WALTON LOFTS WESTERN AVE & VINE ST SEATTLE, WASHINGTON

DESIGN RECOMMENDATION DPD PROJECT #3002311 JULY 16, 2013

DESIGN RECOMMENDATION MEETING

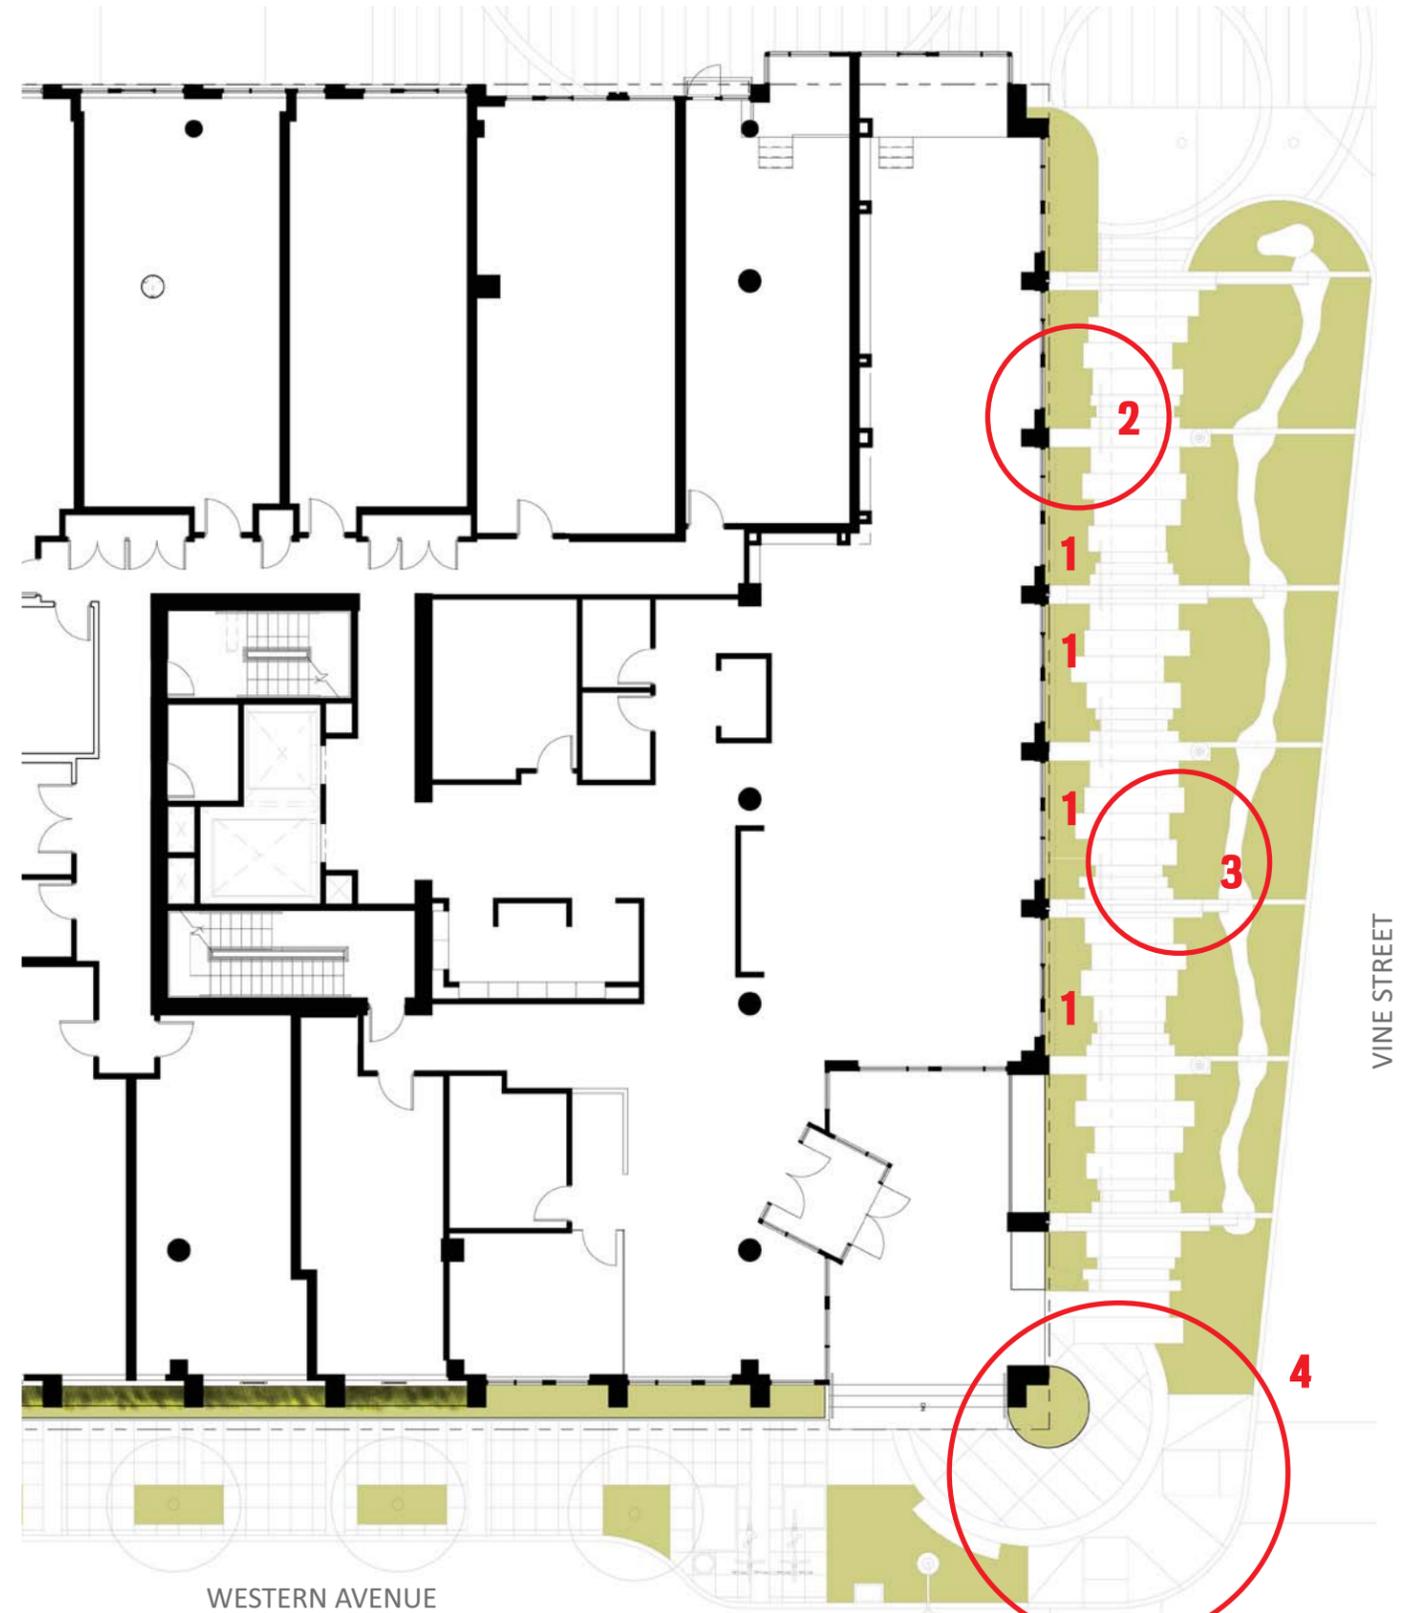
DRB Guidance (EDG 2/3/11): Based on public comment heard by the Board, the landscape architect should continue to refine the design for Vine Street. The Vine Street design seems too monumental. Observations by the Board included that the runnel appeared too private and rigid.

DRB Guidance (EDG 2/3/11): The designs for Western Avenue, Vine Street, and the alley should contribute to creating a singular sense of place. The collaboration between the development team and the community ought to continue in order to support this goal. The introduction of art and hand crafted or individualized architectural and landscape elements will also contribute to making this a reality.

We have responded to this guidance and to the input of the community by locating local artisan-fabricated elements within the pedestrian environment – along the alley and along the Vine Street hill climb. We have approached Belltown’s Black Dog Forge to provide the design and fabrication of the iron greenscreens, handrails, and other elements.

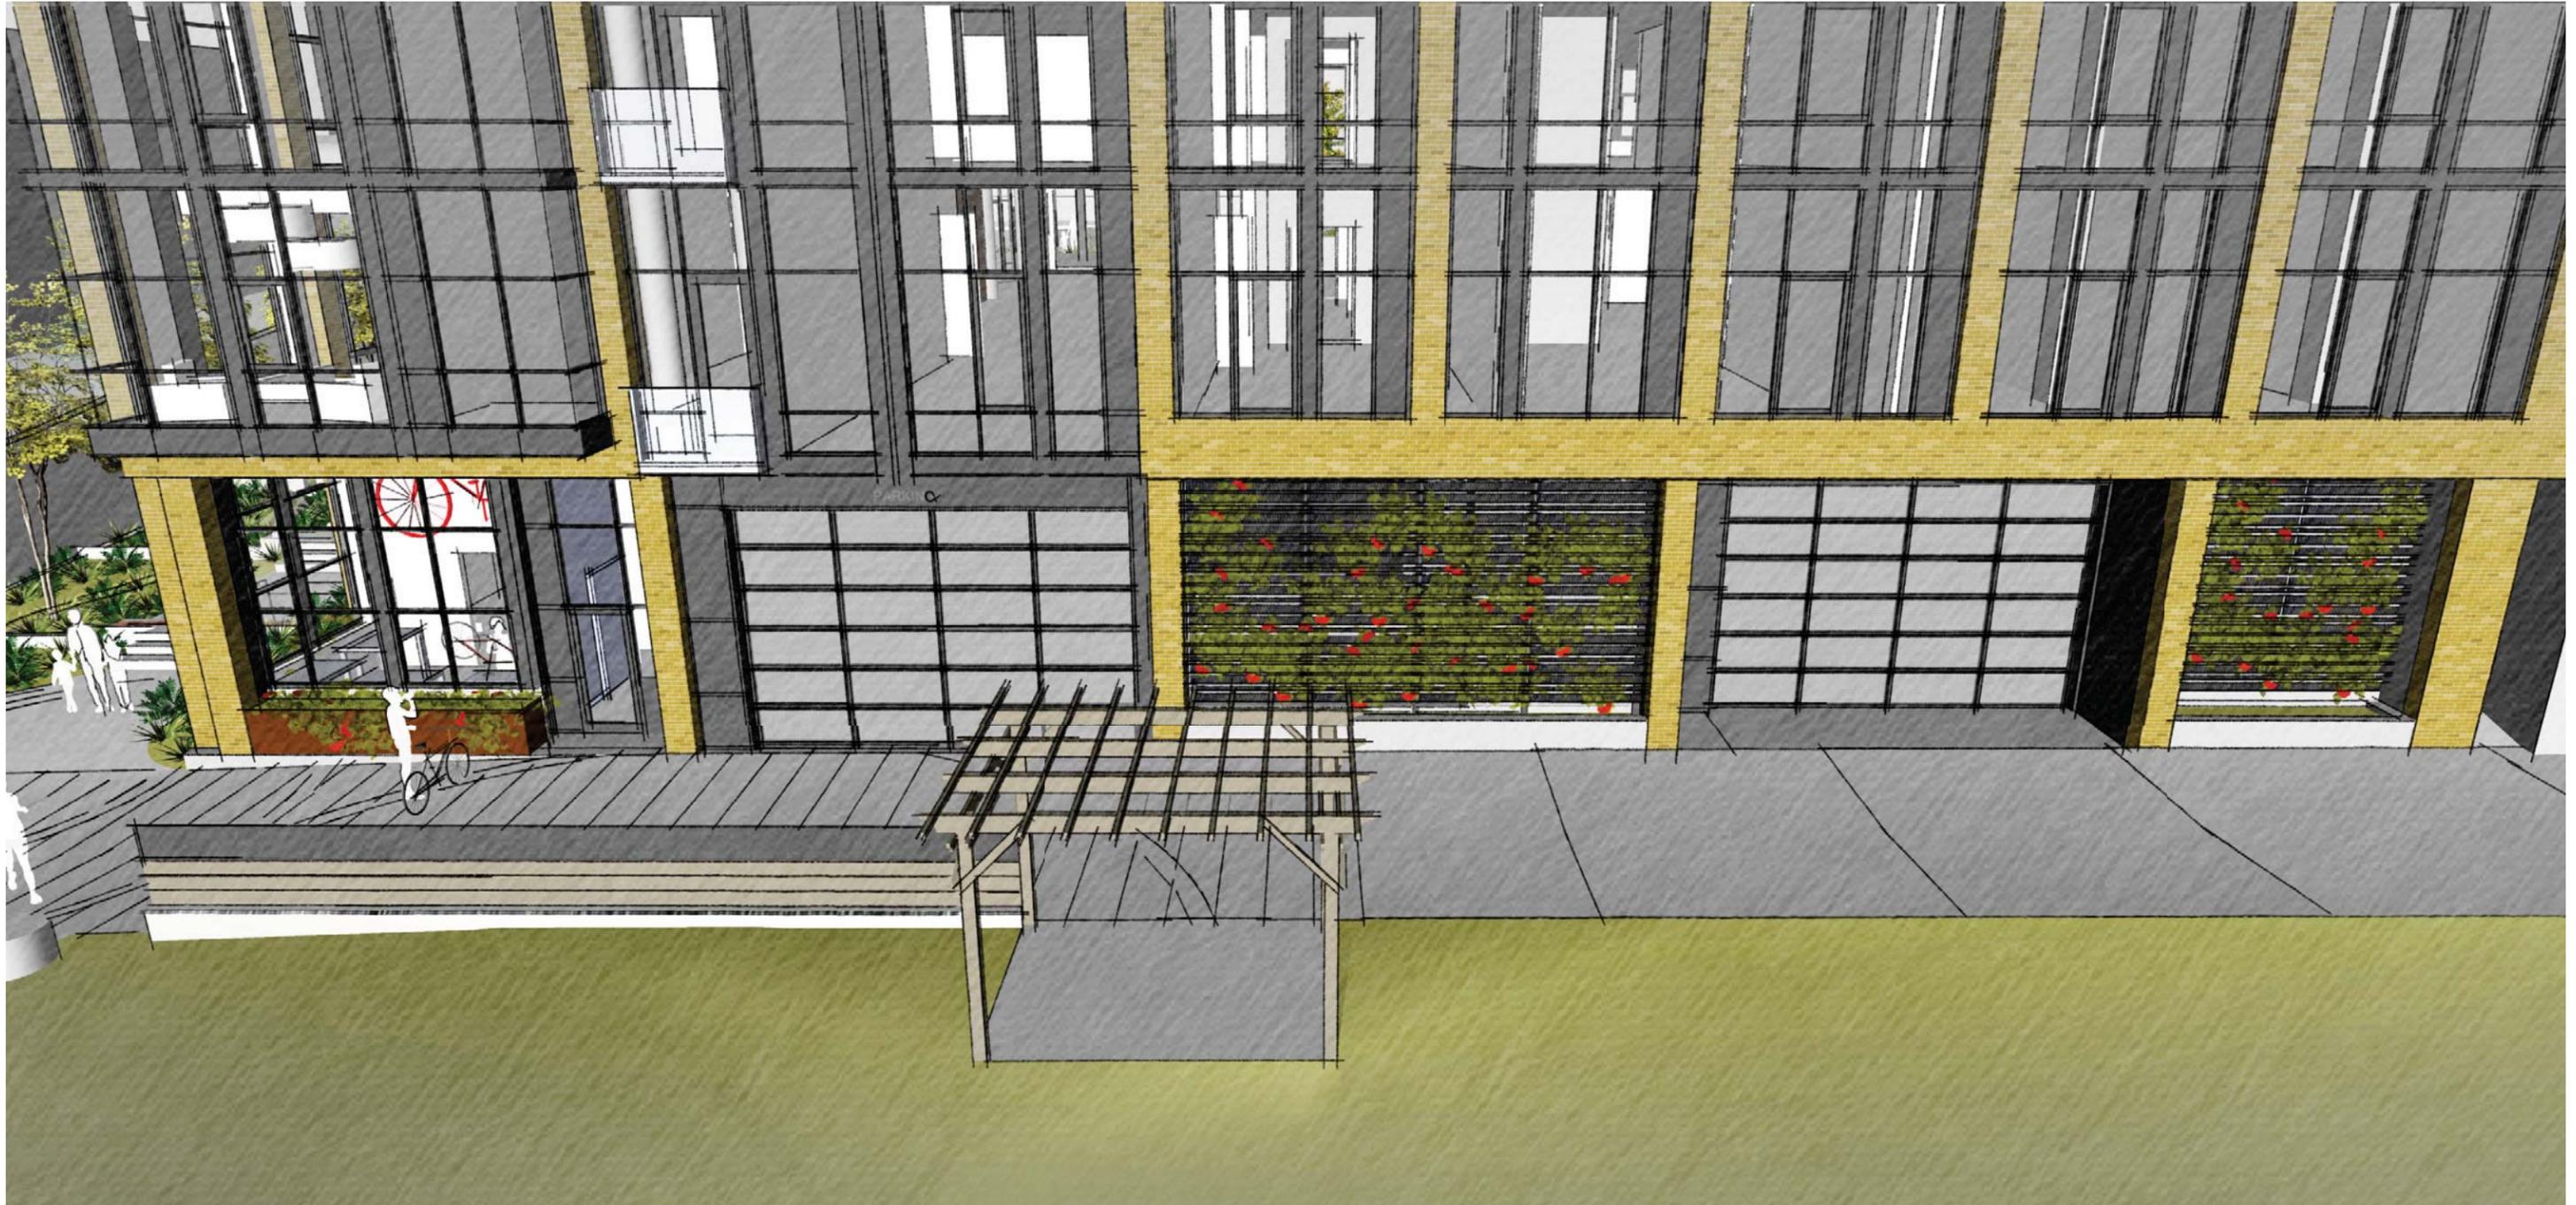
DRB Guidance (EDG 2/3/11): Greater consideration should be given to the elevation of the bike storage area facing the alley and the plaza connecting with the P-Patch. The wall should possess greater transparency. The bike storage space should have the flexibility to change into a more active use over time. Endow this corner space with a presence (and possibly a use) that interacts with the P-Patch.

slight aerial view of alley facade, looking over P-Patch park pergola

VIEW CORRIDOR DECK @ NORTH FACADE - detail showing "juliet" balconies at view corridor

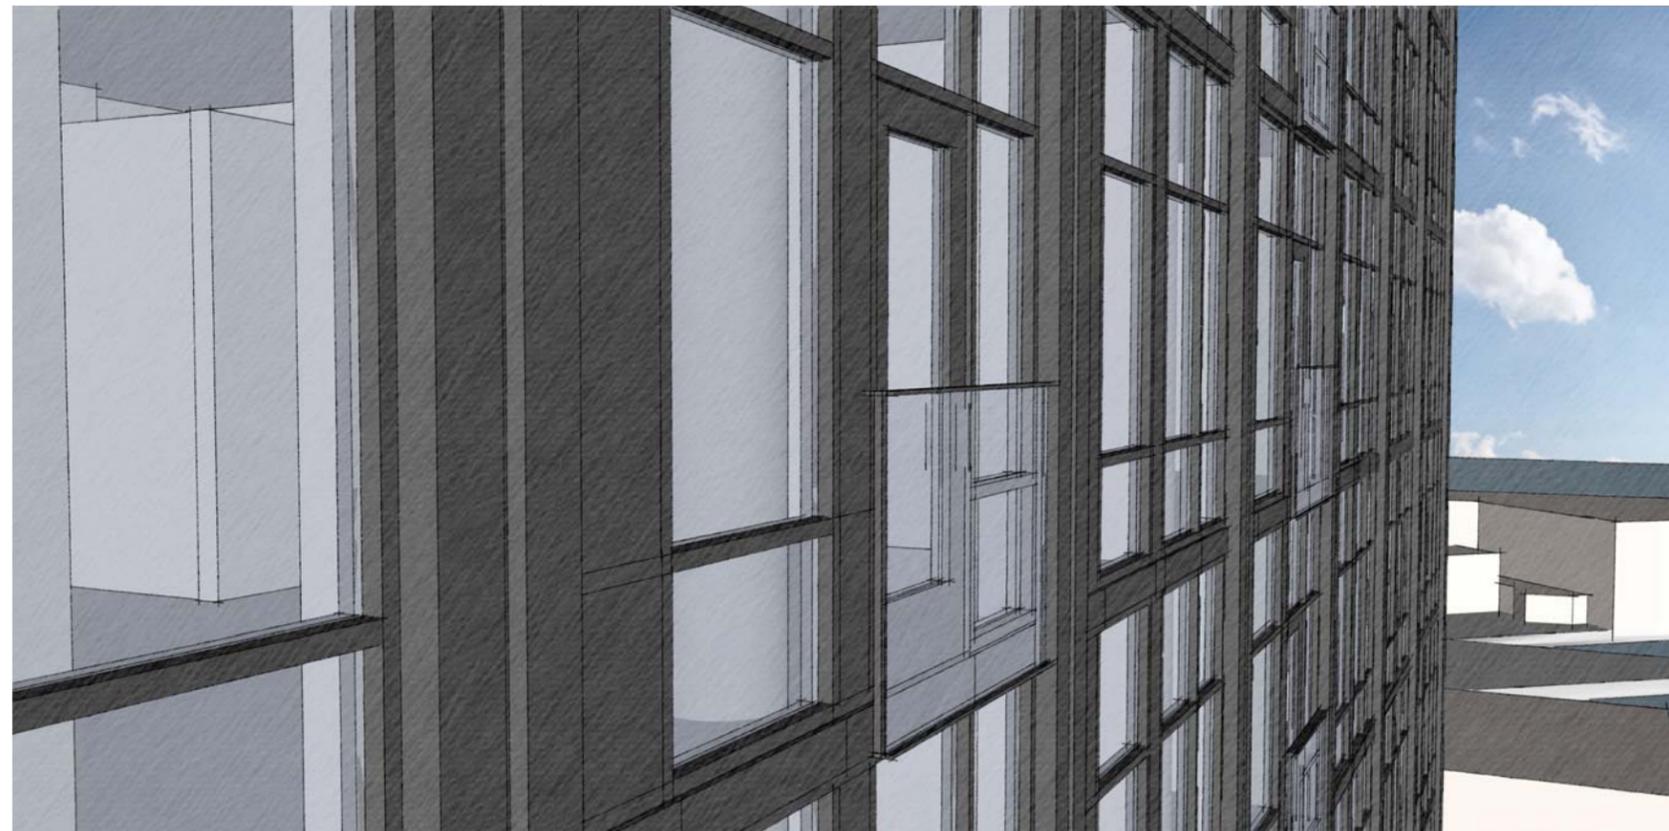
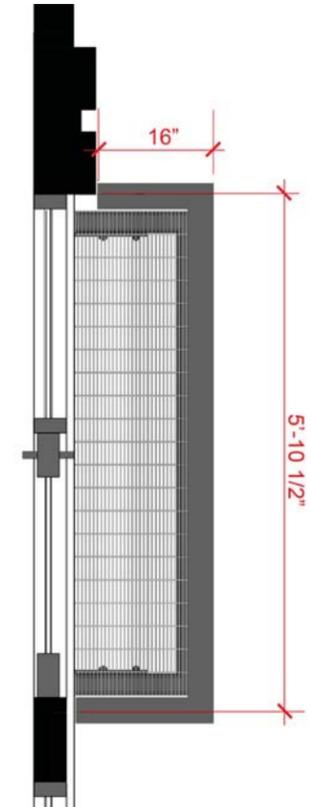
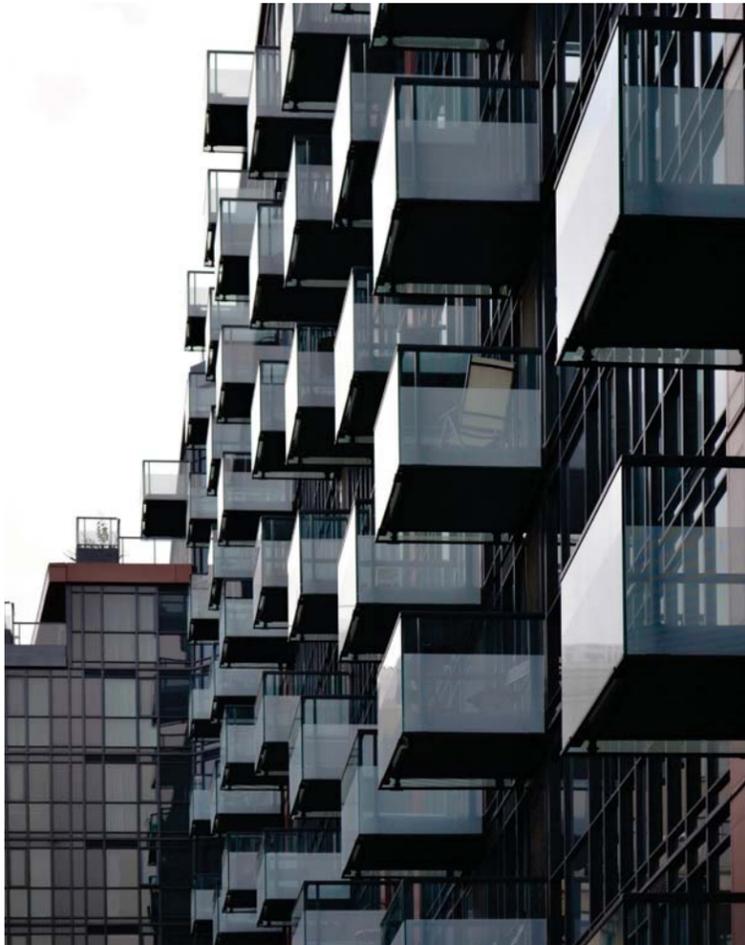
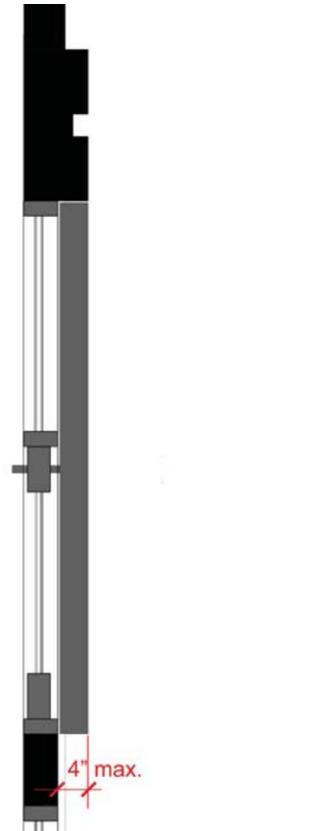
Recent interpretations by DPD planning staff suggest that a view corridor should be treated differently from other setbacks. Therefore normally allowable projections such as balconies, handrails and planters have been deleted from the proposal.

Decks along the building's north face have been reduced to "juliet" balconies, and do not project beyond the face of the building pilasters. The terrace above the view corridor setback has been eliminated, as have the balcony guardrails and planters formerly occupying this space. The building now conforms to the strictest interpretation of the view corridor. That is our intent.

ROOFTOP

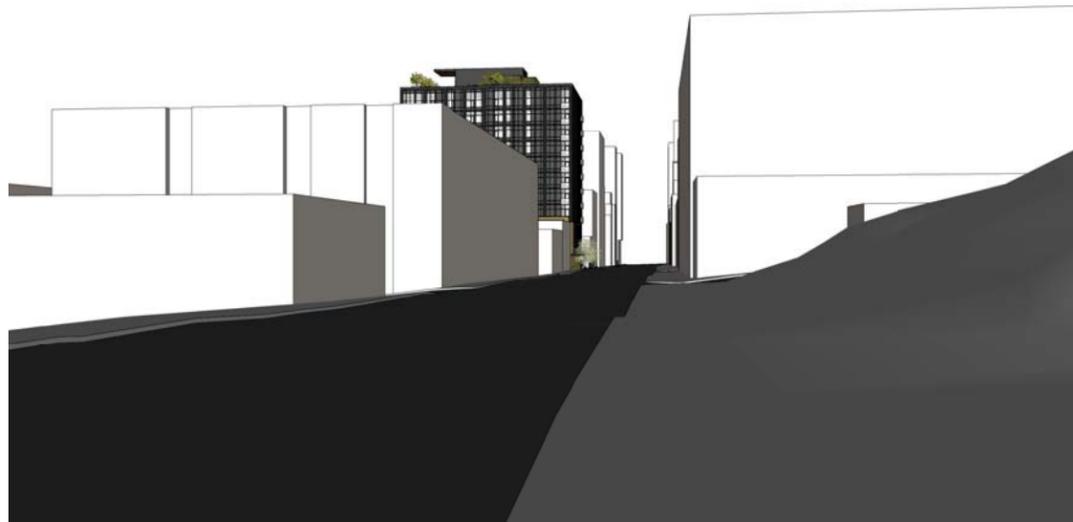
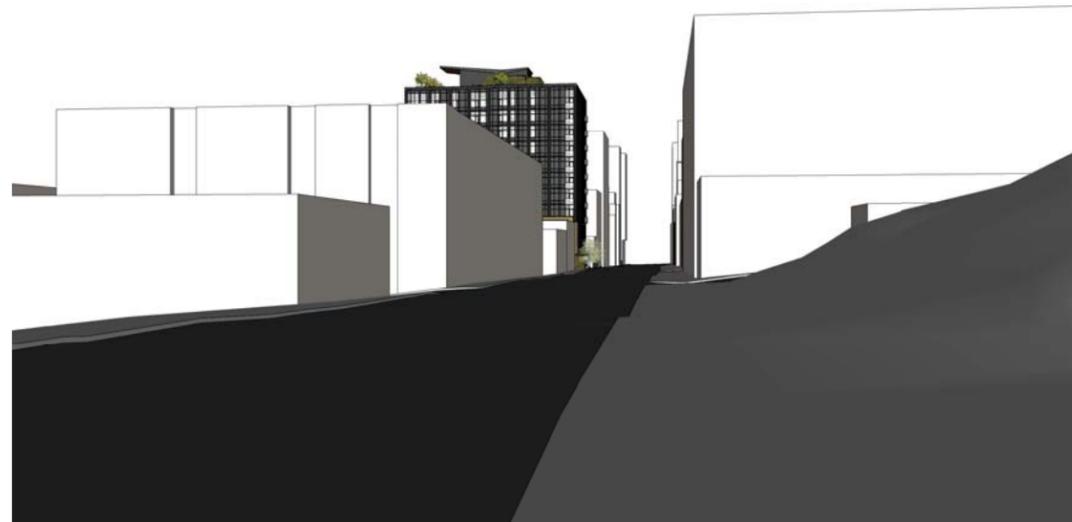
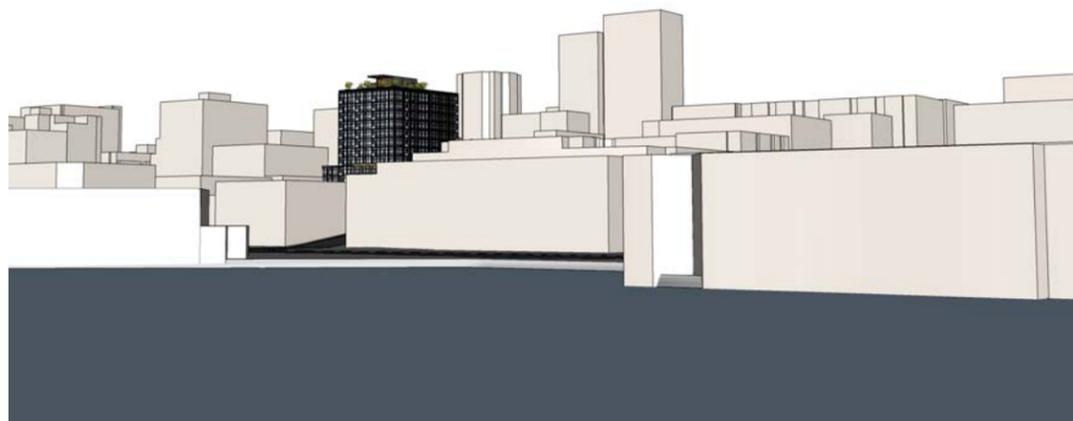
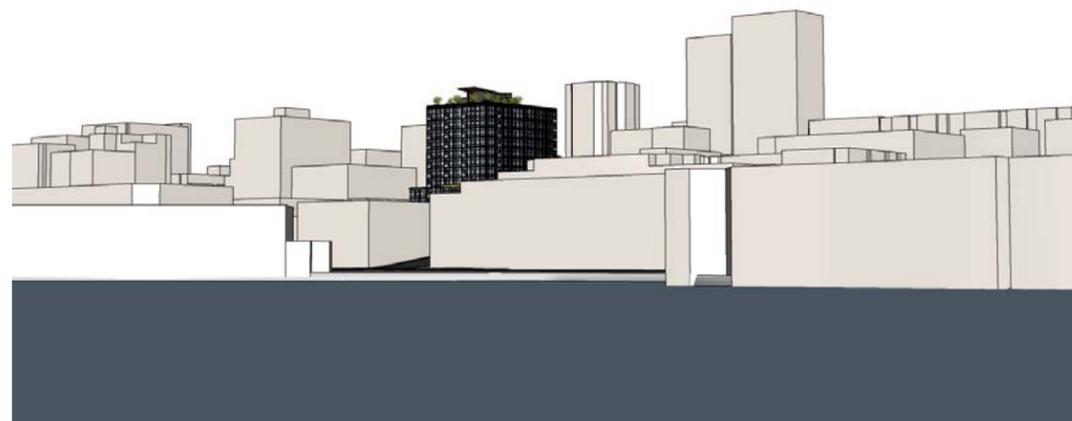
DRB Guidance (EDG 1/8/2013): Responding to public comment, the Board requests more information about the placement and the characteristics of the mechanical penthouses. Atop some of the neighboring buildings, these equipment towers have interesting design characteristics which relate to the community's interest in providing exceptional and artistic infrastructure.

DRB Guidance (EDG 2/3/11): Although the applicant provided designs for the rooftop, the Board, responding to public comment and its earlier guidance, requests a much more interesting presence for the mechanical features and amenity space. The design ought to possess the interest and integrity similar to the rooftop of the Banner Building.

We've tried to do two things -- to minimize both the scale and the visual impact of the building's mechanical screens and elevator penthouse, and to provide shelter for the rooftop common space most dedicated to dining, barbeque and social gathering. We find that we can live within the allowable height for mechanical screening, for everything -- including the elevator overrun and machine room penthouse. We find that we can saddlebag smaller mechanical and electrical spaces against this taller mass, to diminish the unbroken mass and to cluster these elements closely toward the center of the building, and away from the nearest residential neighbors.
